RE: Draft Permit Review Comments
FLD 981-928-484
Used Oil Processing Facility Permit No. H016-308146
Duval County - Used Oil Processor
Industrial Water Services, Inc.
Mittauer & Associates, Inc. Project No. 9122-27-1

INDUSTRIAL WATER SERVICES, INC.
Used Oil Processing Facility Permit
Topographic Map
Jacksonville, Florida

INDUSTRIAL WATER SERVICES, INC.
Used Oil Processing Facility Permit
Topographic Map
Jacksonville, Florida

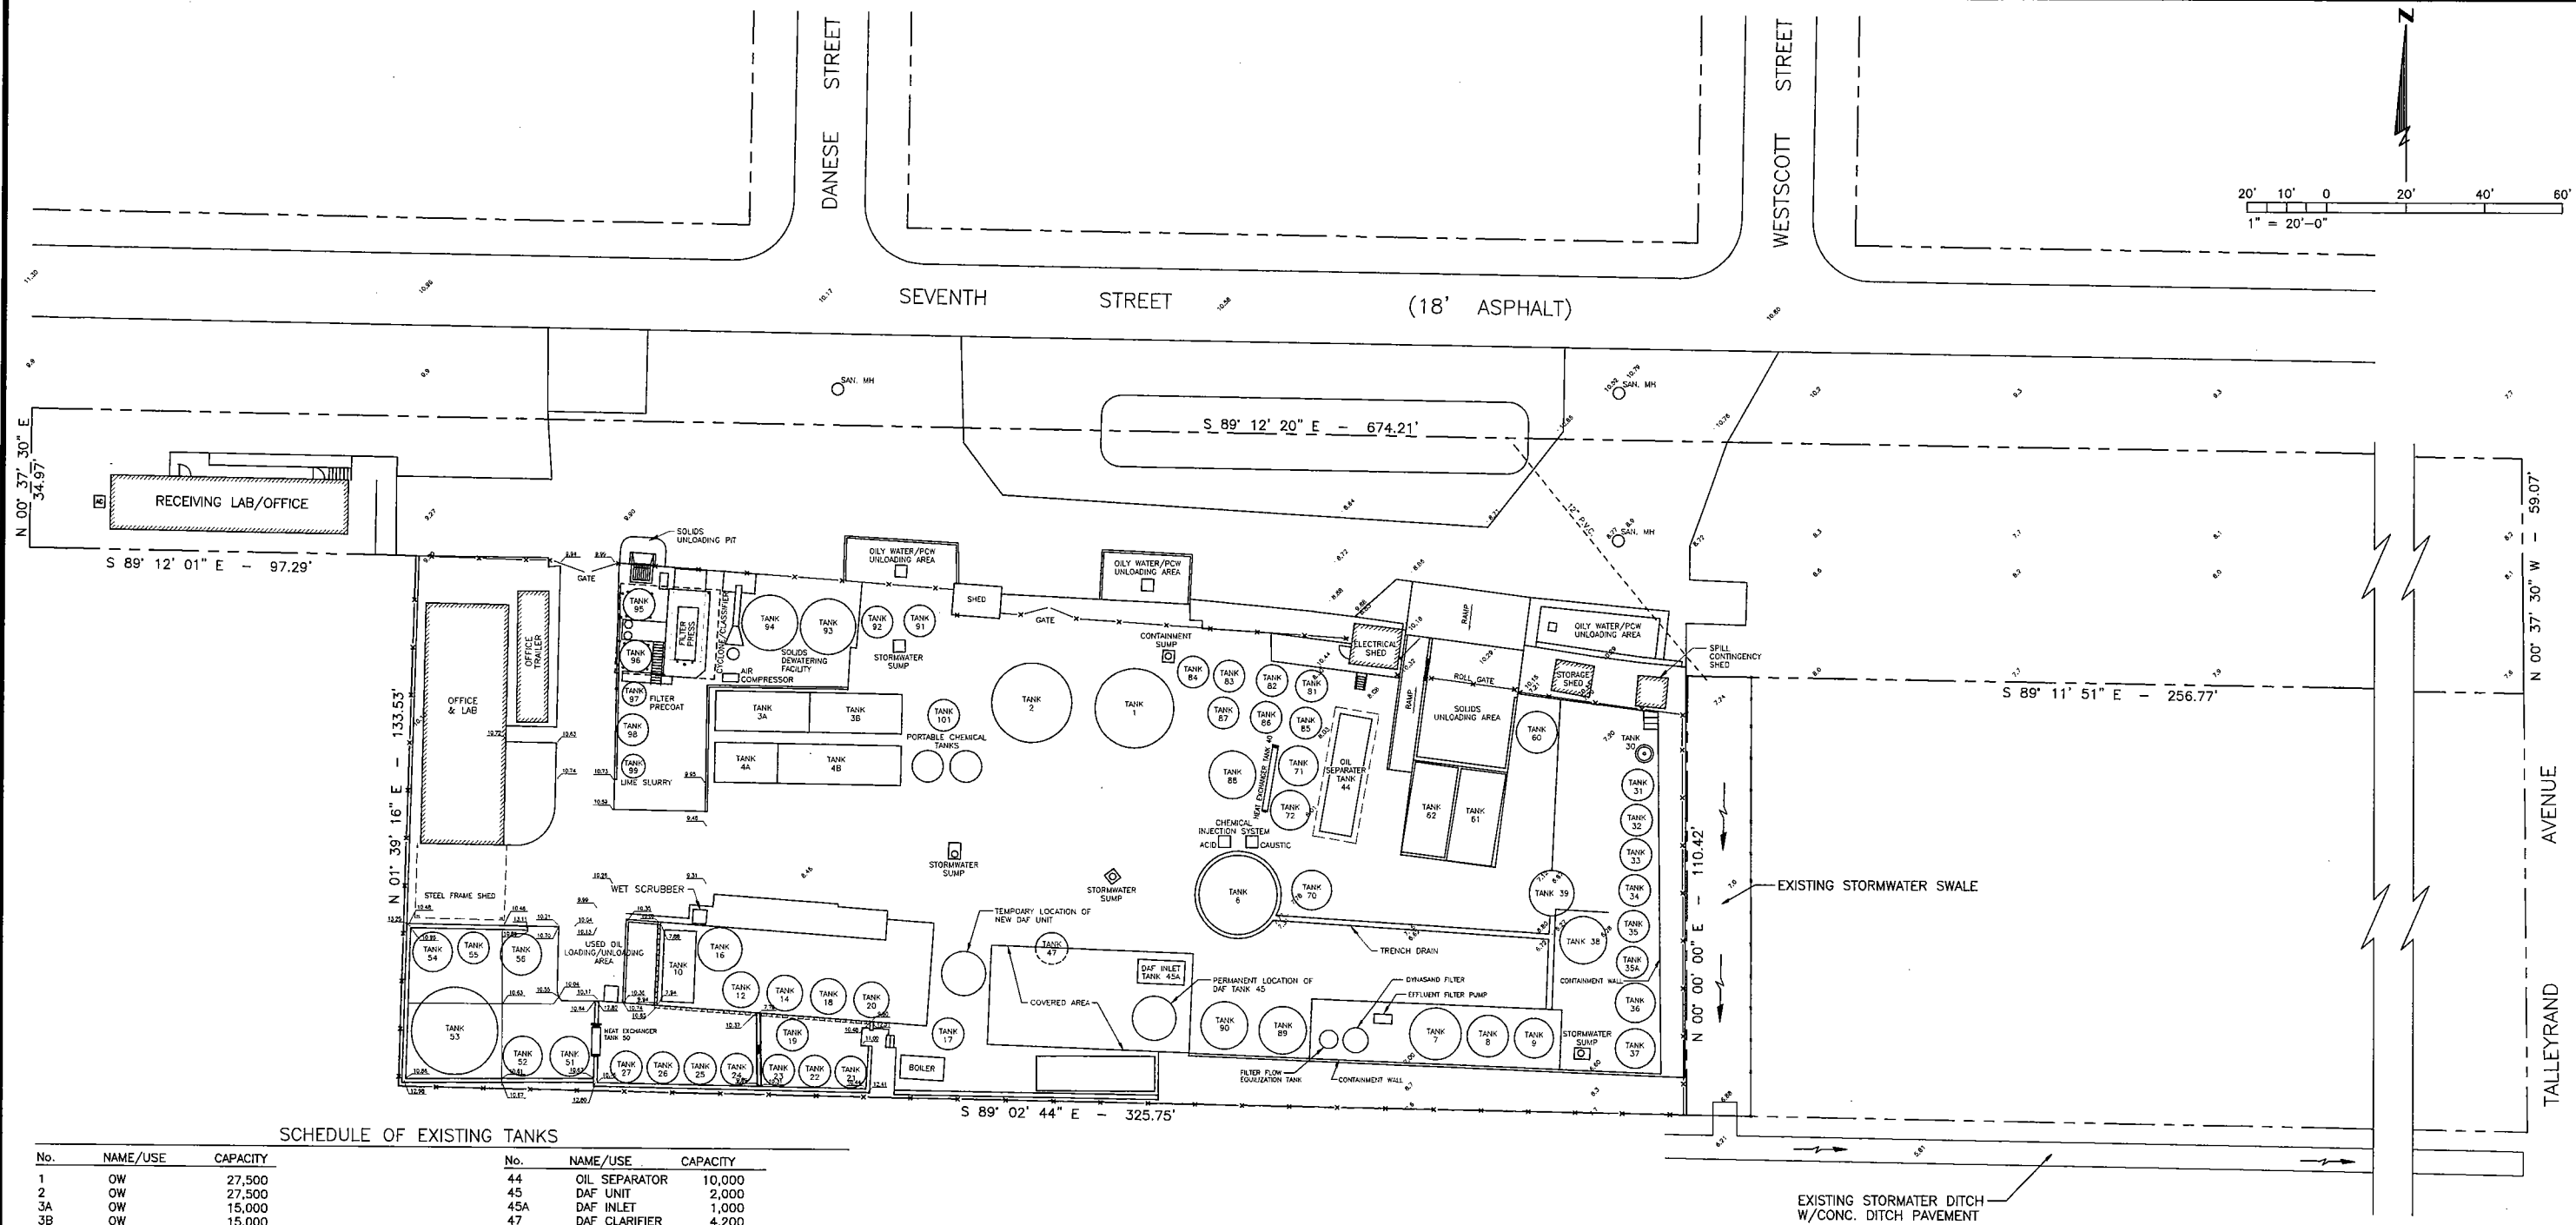
1. Attached you will find a revised tank schedule for the facility. The summary at the bottom of the previous tank schedule (Attachment B of the permit) was revised to reflect the correct number of tanks and their capacities.
2. Accordingly, it was noticed there was a discrepancy on the site plan tank schedule for the facility as well (Attachment A of the permit). Attached you will find a revised site plan for the facility.
